# Westwood Fire Department – Main Fire Station

## Town of Westwood ADA Transition Plan

May 2023

Institute for Human Centered Design

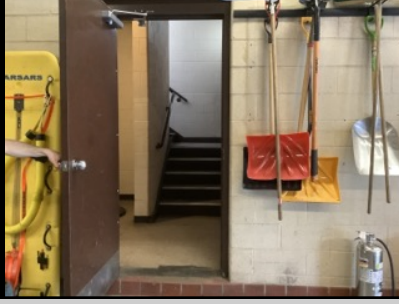
- At the slight transition in the apparatus truck bay from the driveway, recommend painting the transition a contrasting color, to prevent members of the public from tripping.

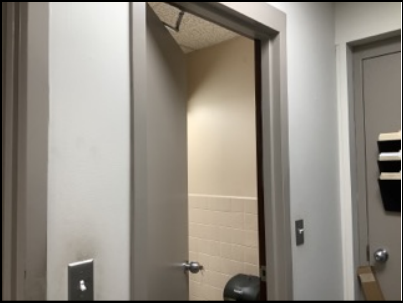
- At the service counter in the lobby, recommend providing an additional speak-through hole at a lower height for wheelchair users and persons of short stature.
- Recommend providing contrast strips on the treads of the exterior stair.
